**MINUTES
BOARD OF BUILDING STANDARDS/
ARCHITECTURAL BOARD OF REVIEW/SIGN REVIEW
REVIEW MEETING
CITY OF LAKEWOOD
12650 DETROIT AVENUE
AUDITORIUM
OCTOBER 10, 2024
5:30 P.M.**

Applicant proposes final designs for a planned development consisting of ten townhouse units and one single-family house. (Page 244)

ARCHITECTURAL SITE PLAN
1" = 20'-0"

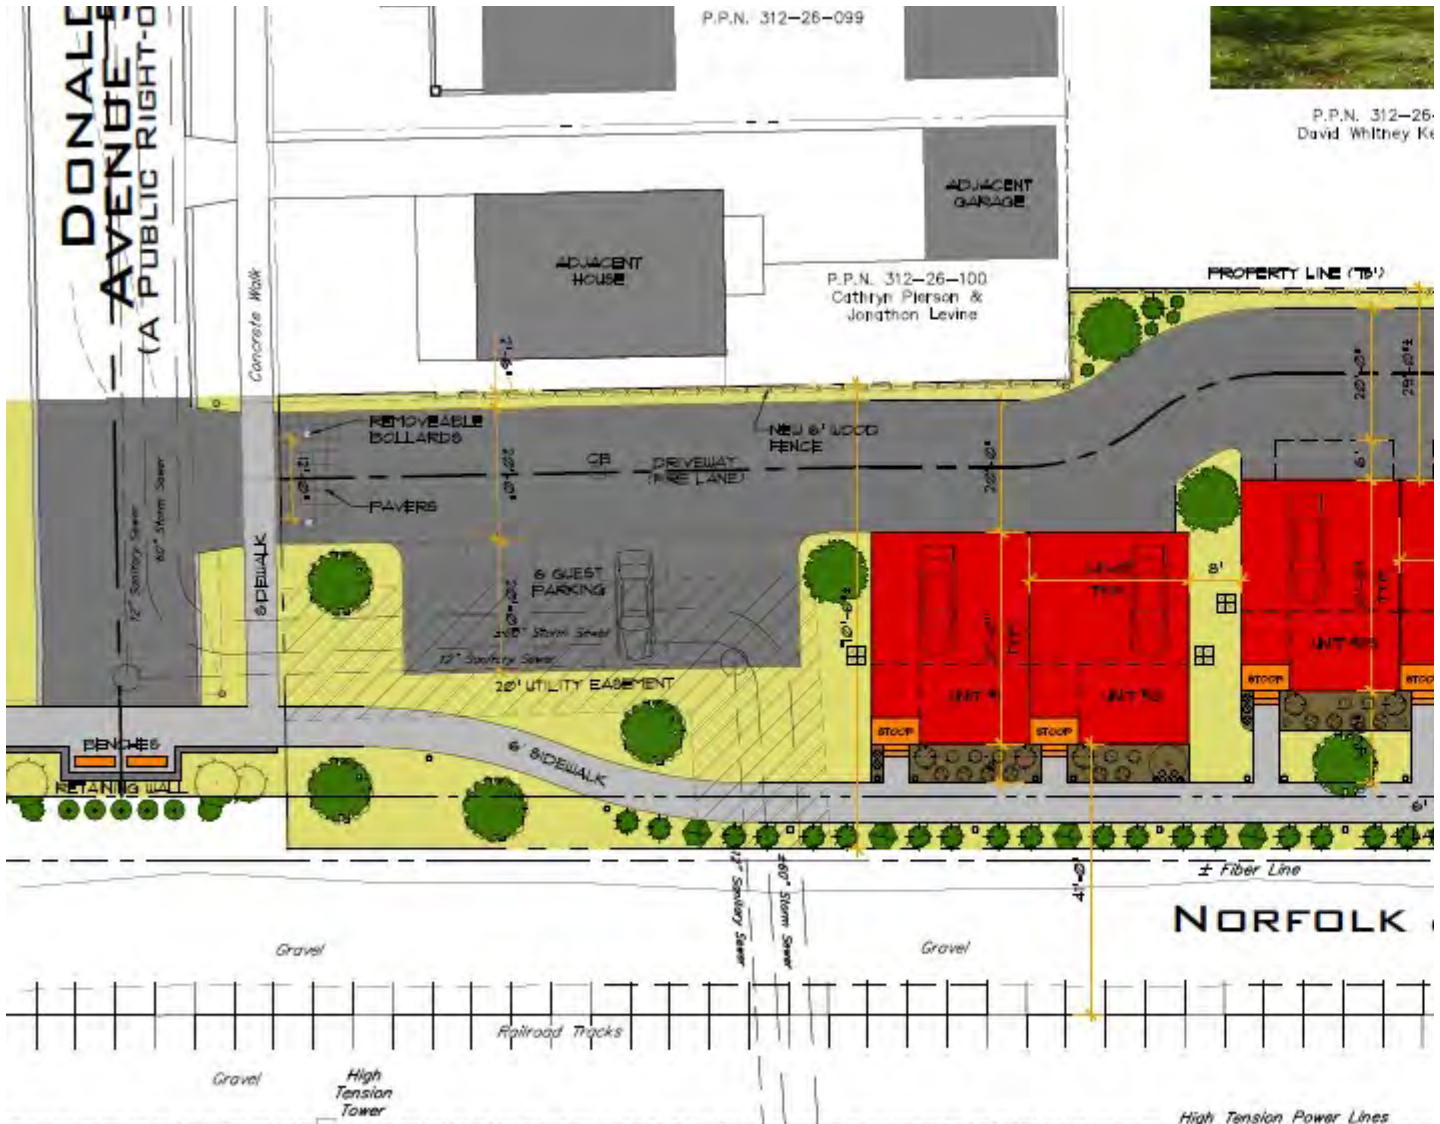
Unfortunately, the latest plans (images below) have not taken into consideration any of the suggestions from the neighbors. We've asked that the road and housing be switched around so that the road would run along the railroad. The latest drawing below shows that they haven't been willing to take that into consideration. Additionally, we've asked that a larger landscape buffer be included, but this has actually been reduced to allow for now a wider two-way street. My understanding is that the buffer dimensions do not fall within the existing code. I also wonder if a street is added why it wouldn't be one-way letting out on Donald to reduce safety concerns of the nearby Cove Park entrance?

We continue to be dismayed by the lack of consideration to existing neighbors throughout this process. This is a very slippery slope that the ARB and Planning Commission have decided to take. If this rezoning is approved from Residential parcels to Planned Development then it's likely what's to come throughout Lakewood. Hoping that you'll help to facilitate more productive results within the existing code before it's too late.

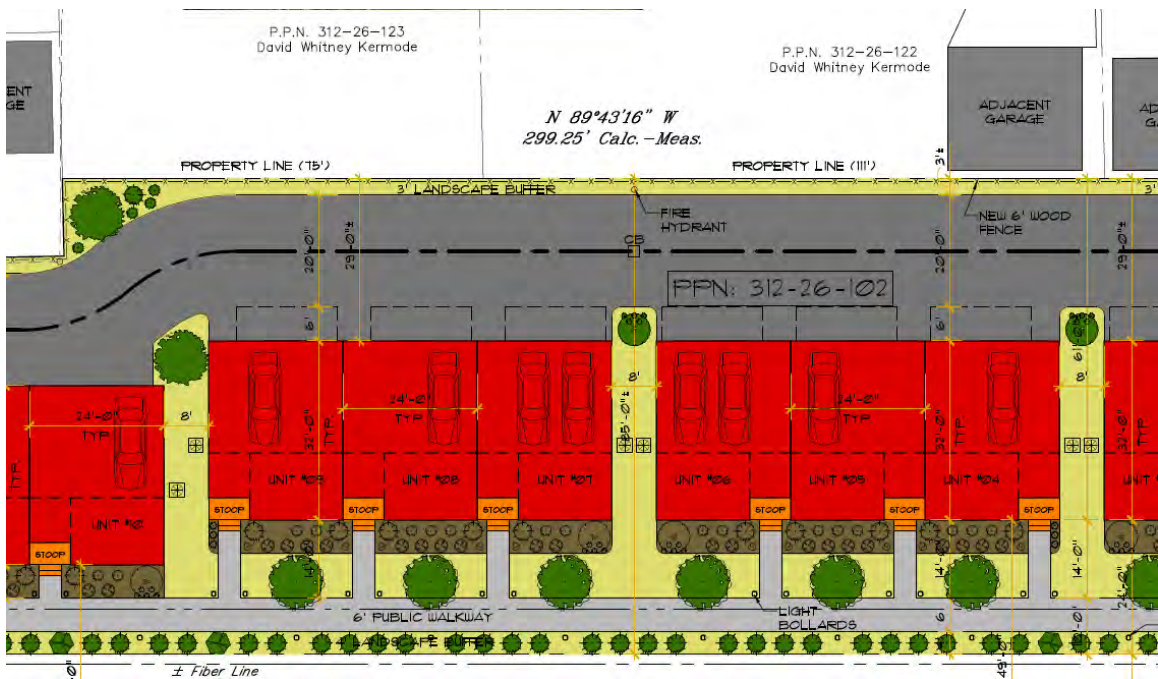
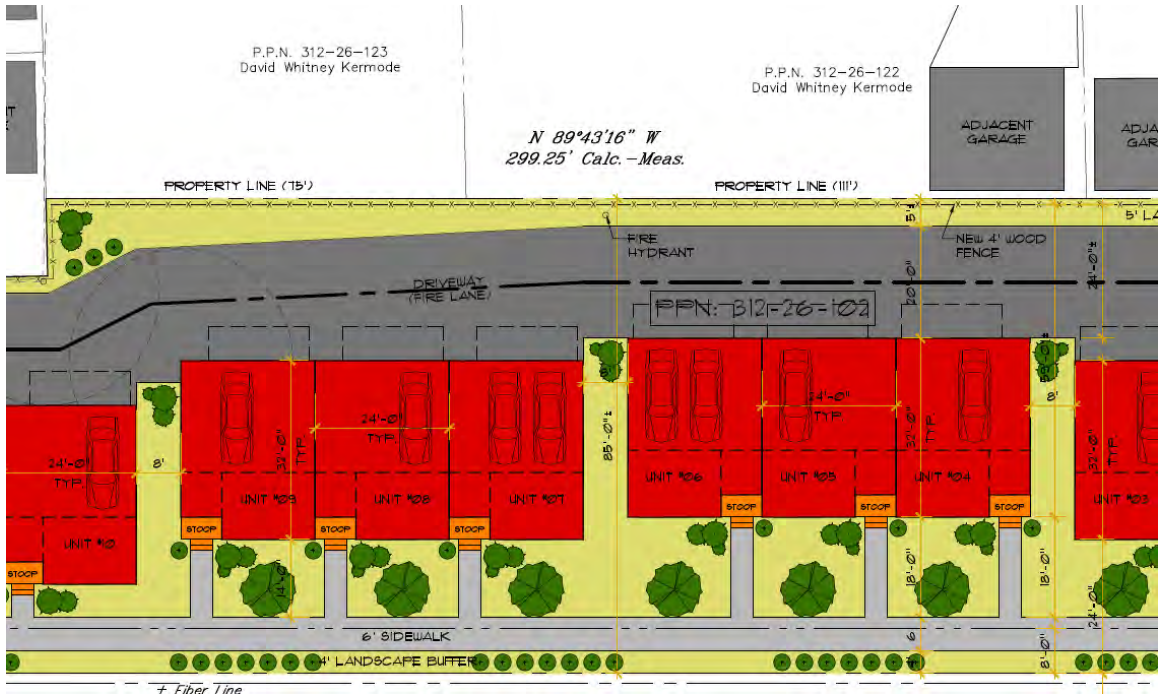
When opening the latest set of plans, it appeared to specifically make worse clearly conveyed areas of concern including the width of the buffer (5' to 11' as of the plan prior to the meeting, now reduced to 3' without any landscaping apart from grass seed) which was requested to be widened to account for spillover impacts of road salting on neighboring landscape that's more heavily impacted, along with vertical planting in excess of the fence height to mitigate the elevated balconies that have very clear viewsheds over the majority of my home and yard, including my own landscaping. That was left out entirely.

- My submitted feedback has noted concerns regarding the interface between the property boundaries. My previous comment noted that the approximately 5' to 11' foot (running from east to west) boundary was inadequate. The revised plan now reduced this further to 3'. I would hope the commission could more forcefully push back on the applicant on that point and good faith efforts to engage with contiguous property owners on material and detrimental impacts created solely by the development as proposed. The following shows the evolution of the plan despite this specific issue being raised with the applicant.

- The proposed three foot grass strip along the northern property line adjacent to the proposed 20' to 26' wide through roadway is even more wholly inadequate for any meaningful screening. Further, the plans as presented appear to lack any planned landscaping apart from a six foot fence and grass seed for the strip between the proposed roadway and the northern property line.

- The further narrowing of the strip from the prior plan now renders this a more significant issue as it bring the parking, loading and circulation infrastructure and plowing needs closer to the property line with detrimental and demonstrable impacts on the plants I have along the border (see addendum with replacement mature tree pricing and information regarding salt sensitivity for both ground intrusion and any salt/airborne salt due to drier winter conditions). Norway Spruce are notably sensitive to road salt, which are the largest concentration (12 total) of trees along the southern border of my parcels, which would only present due to an overwide parking, loading and circulation infrastructure that would not have been legally permissible nor was existing when the landscaping was installed.
